# Value Engineering

FINAL REPORT

Elwha River Restoration, Glines  
Dam Removal

DATE: December 15, 1995

# ORIGINAL CONCEPT - GLINES CANYON DAM

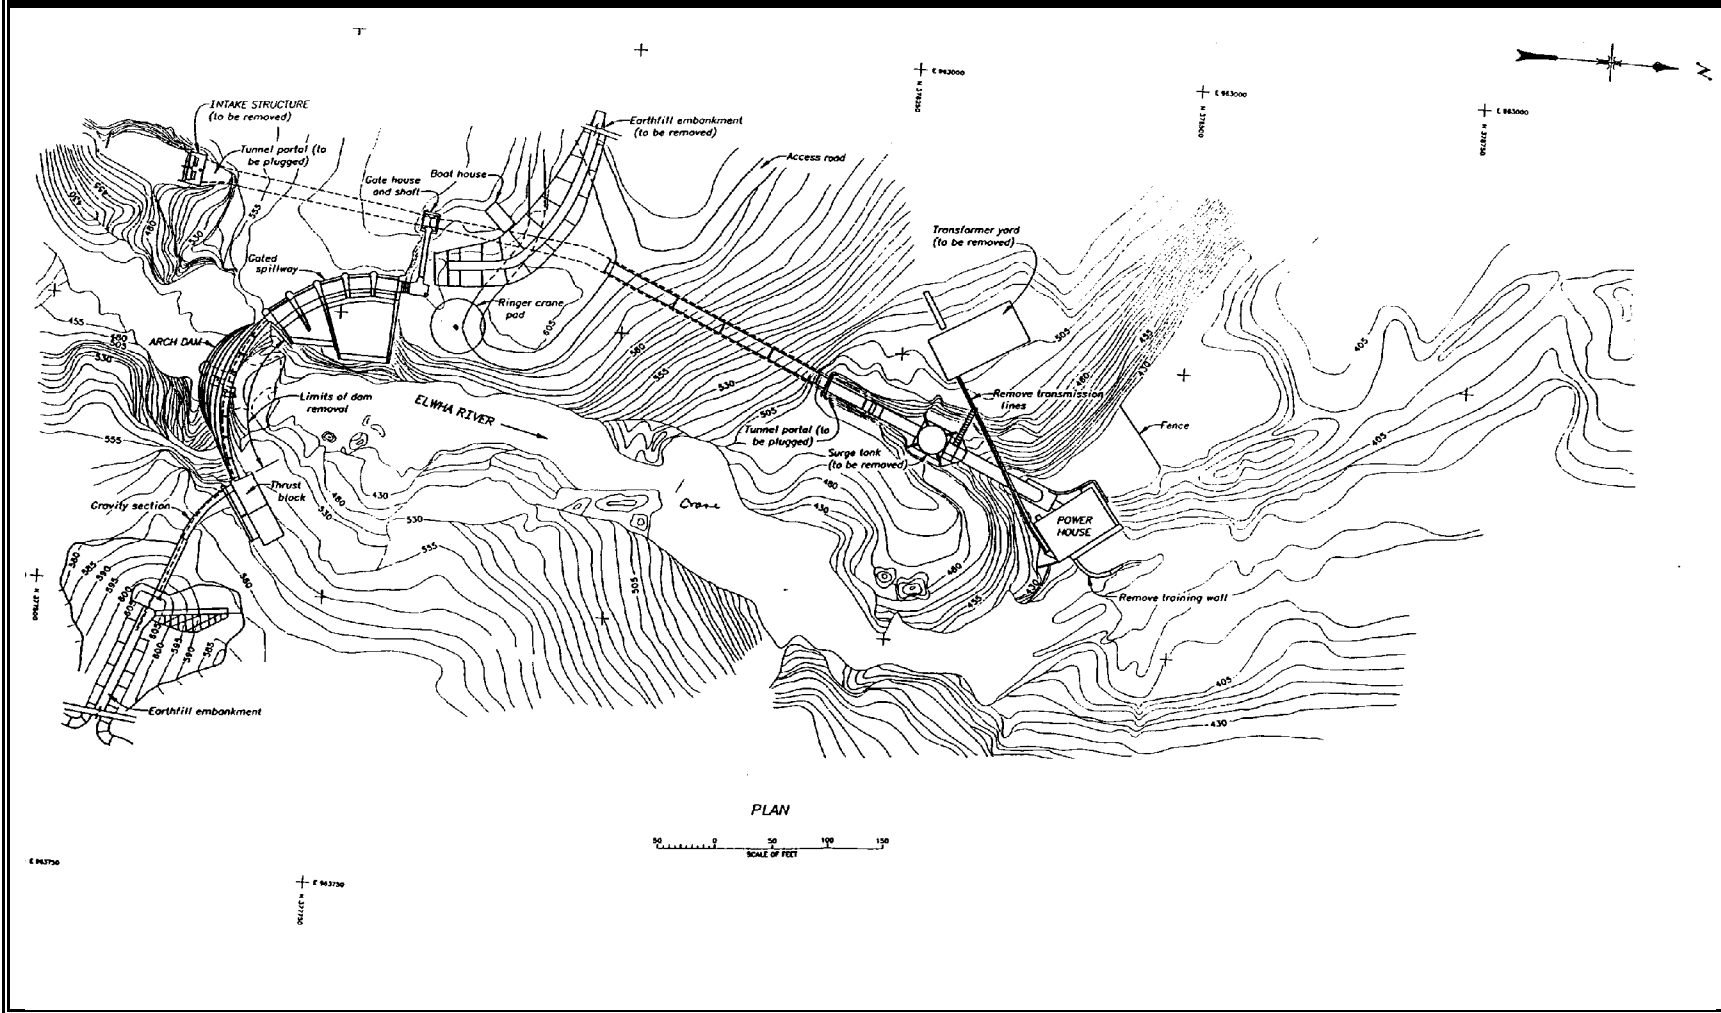
The current proposal calls for the complete removal of Glines Dam. The dam would be removed using a combination of controlled blasting and diamond-wire sawcutting. The concrete would be removed in block form. The dam would be dewatered through the existing dam penstock to elevation 537.8, and then dewatering would occur through a series of alternate "notches."

# VE PROPOSAL NO. 1 – Dam Section

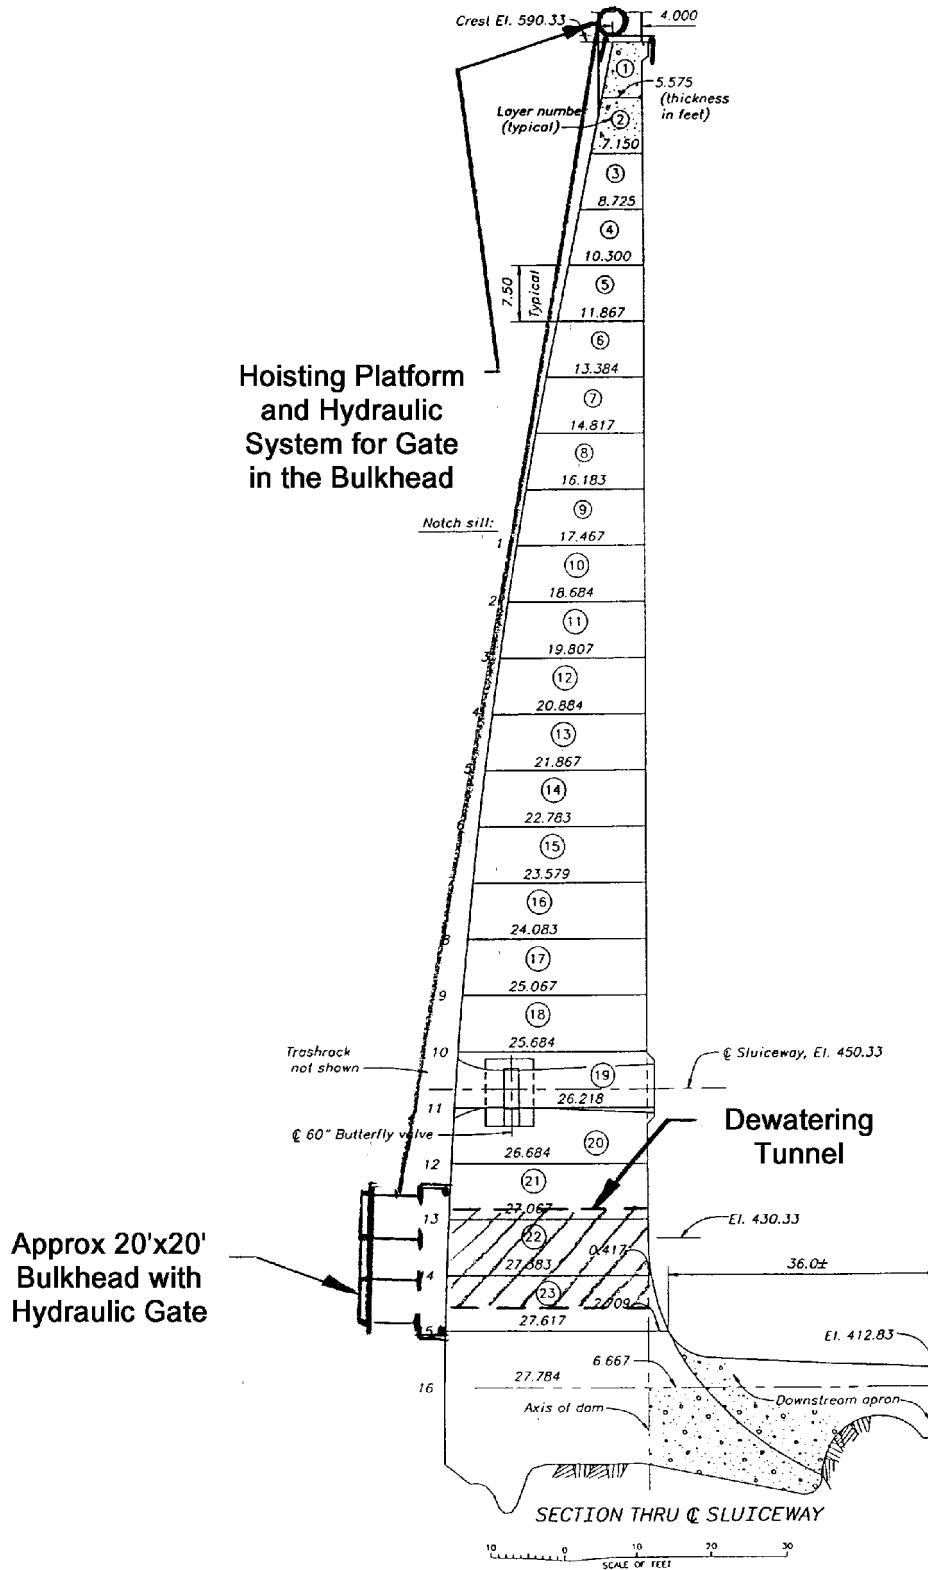
A tunnel would be cut through the dam at the streambed level. The tunnel would be approximately 27 feet long and at least 10 feet in diameter. Prior to daylighting through to the upstream side, the sediment would be removed to a distance of approximately 200 feet upstream of the dam. The bulkhead would be constructed and lowered from a barge to cover the upstream portal. The impounded water will drained through a bulkhead with gates. After drainage is complete the hole would be enlarged to the extent necessary to safely pass the 500-year/6-hour storm event. Concrete from the tunnel construction would be used for sediment bank stabilization upstream of the dam.

<p><b>Disadvantages:</b></p> <ol style="list-style-type: none"> <li>1) Requires additional engineering stability analysis.</li> <li>2) Requires upstream sediment removal.</li> <li>3) Increased flood risk during construction.</li> <li>4) Structural analysis may indicate that the tunnel size is impractical.</li> </ol>

# VE PROPOSAL NO. 2 – General Plan

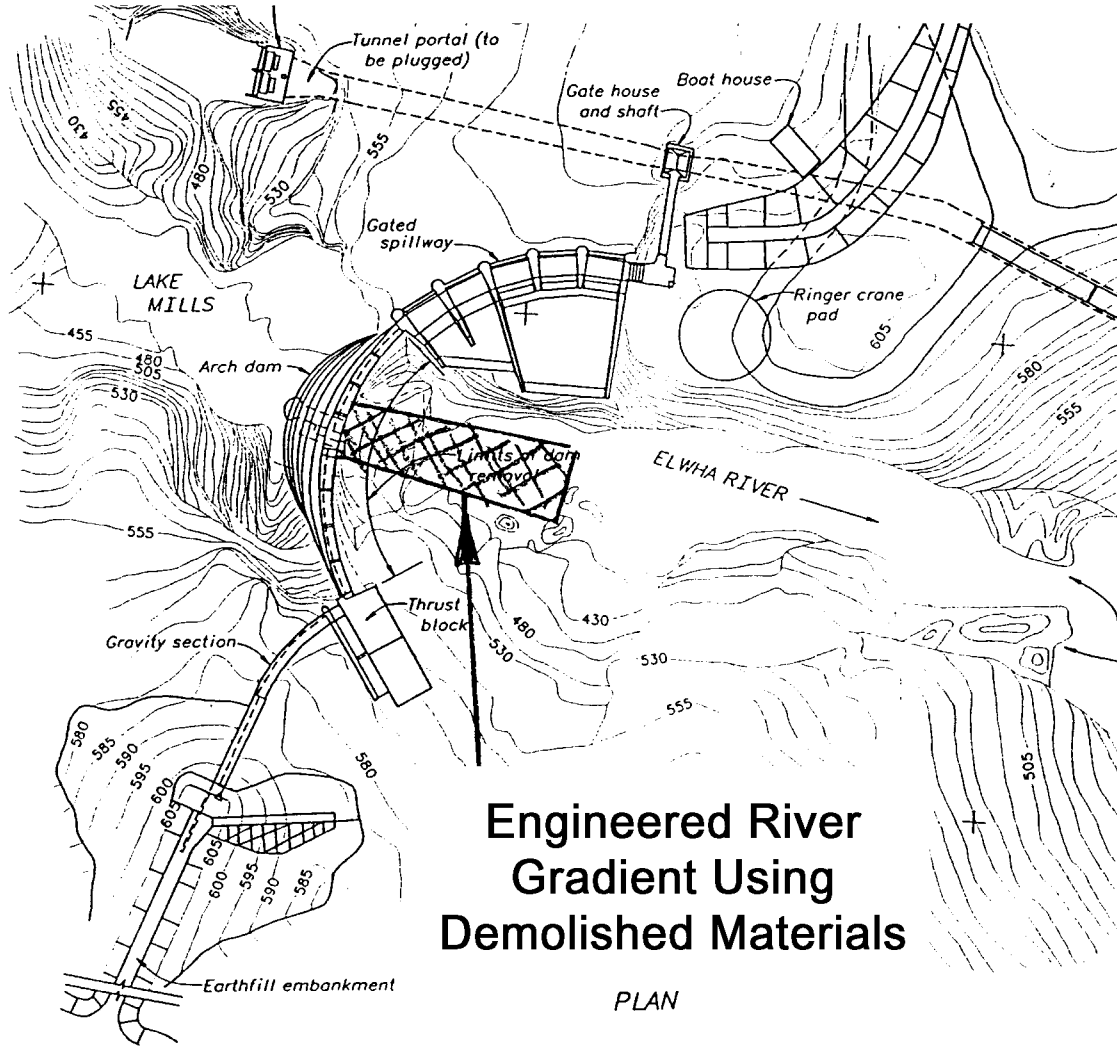
This proposal requires the removal of sediment around the upstream face of the sluice gate area which is approximately 5 to 7 feet below the current sediment pool elevation and for a distance of approximately 100 feet upstream of the dam. A 20-foot by 20-foot bulkhead would be lowered from a barge to the sluice gate elevation. A 10-foot-diameter, 27-foot-long tunnel would be sawed/controlled blasted to the bulkhead from the downstream face. Dewatering to elevation 537.8 would proceed as planned in the original concept. When the initial opening to the bulkhead is complete, the bulkhead gate would be gradually opened to drain the remaining impounded water. The tunnel would then be enlarged to allow passage of the 500-year/6-hour storm event. The removed concrete would be used to construct an engineered river grade downstream from the sluice gate elevation at approximate elevation 445. The river upstream of the dam would be shaped and riprapped for approximately 200 feet through the sediment.

<p><b>Disadvantages:</b></p> <ol style="list-style-type: none"> <li>1) Requires additional engineering stability analysis.</li> <li>2) Requires upstream sediment removal.</li> <li>3) More flood risk during construction.</li> <li>4) Requires engineered river gradient downstream.</li> <li>5) May reduce structural strength of dam.</li> <li>6) Structural analysis may indicate that the tunnel size is impractical.</li> </ol>

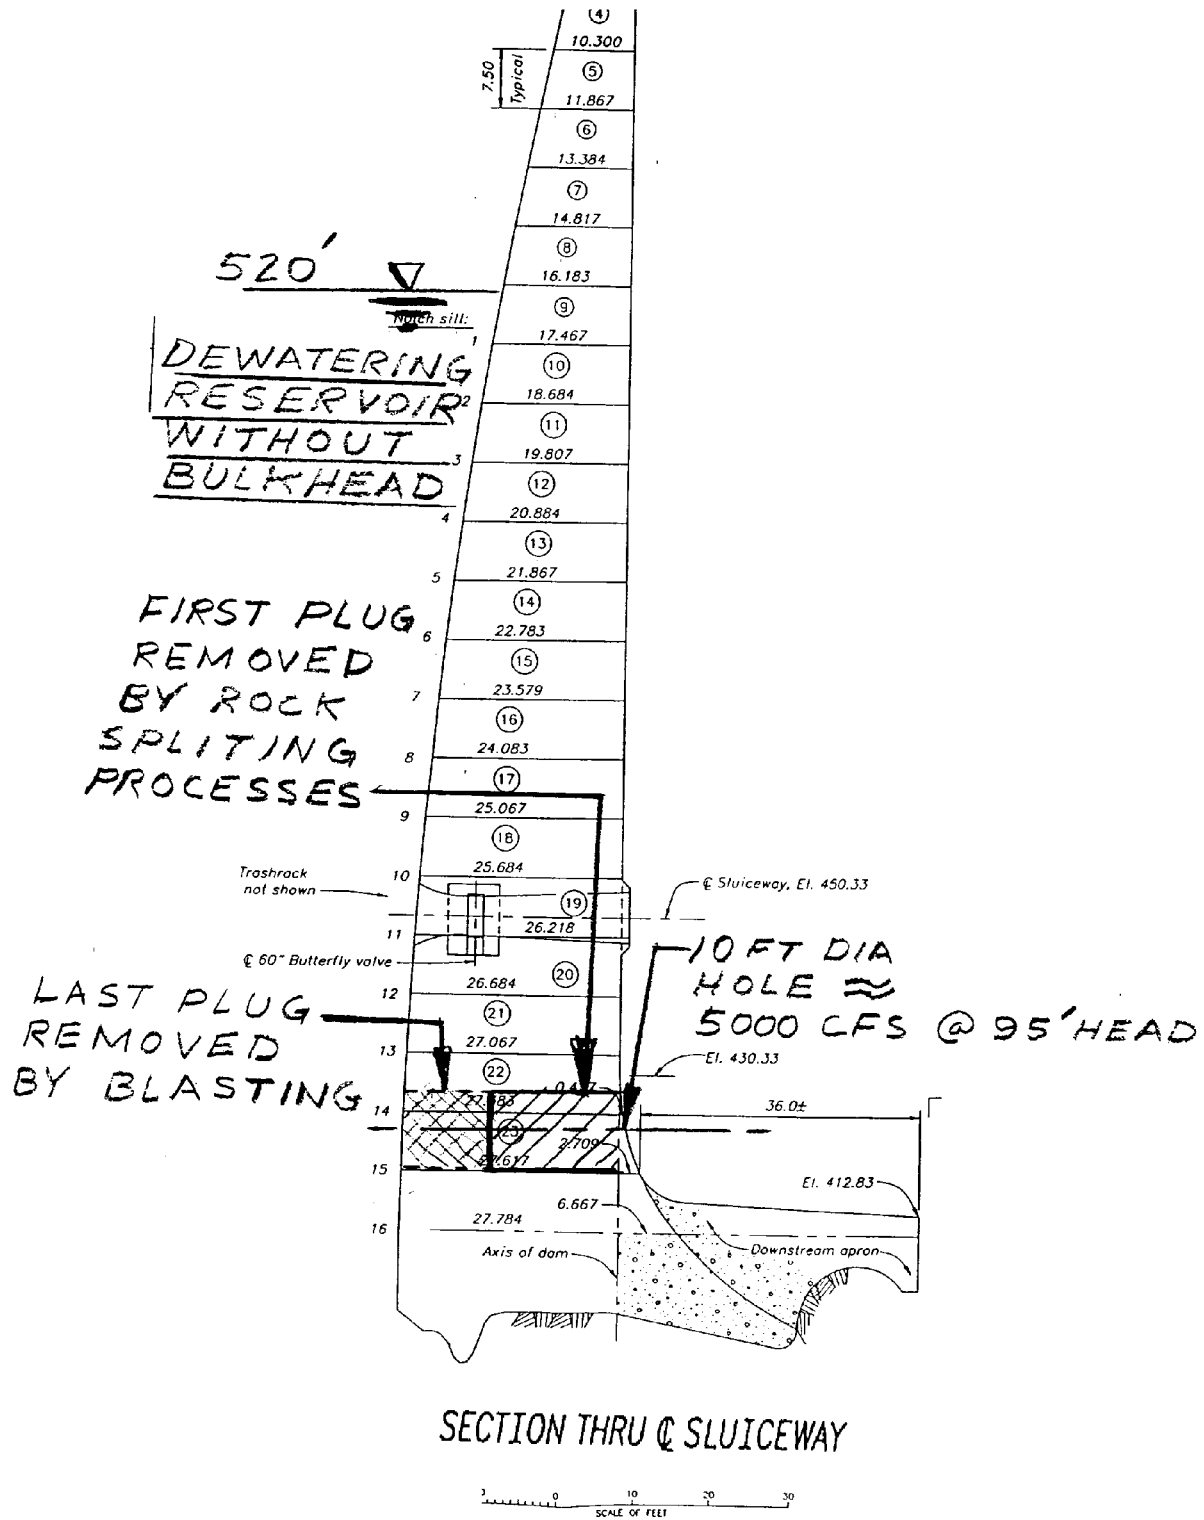
Sediment would be removed to an approximate elevation of 410 feet (approximate apron elevation), and to an approximate distance of 100 feet upstream. The impounded pool would be dewatered to El. 537.8 through the penstock inlet. Excavation of a 27-foot-long tunnel approximately 10 feet in diameter from the downstream face would begin. Excavation would be completed through a combination of sawing and controlled blasting. The excavation would continue upstream until a safe distance from the upstream face where water head would be approximately 120 feet. The final tunnel section is removed by a controlled blast. After the reservoir recedes, and a base flow is established, additional excavation will be completed to enlarge the tunnel. Concrete waste material could be used as riprap for the shaped channel constructed upstream of the dam face for a distance of 200 feet.

<p><b>Disadvantages:</b></p> <ol style="list-style-type: none"> <li>1) Requires additional engineering stability analysis.</li> <li>2) Requires upstream sediment removal.</li> <li>3) More flood risk during construction.</li> <li>4) Uncontrolled releases of water/sediment during reservoir tap.</li> <li>5) Structural analysis may indicate impractical tunnel size.</li> </ol>
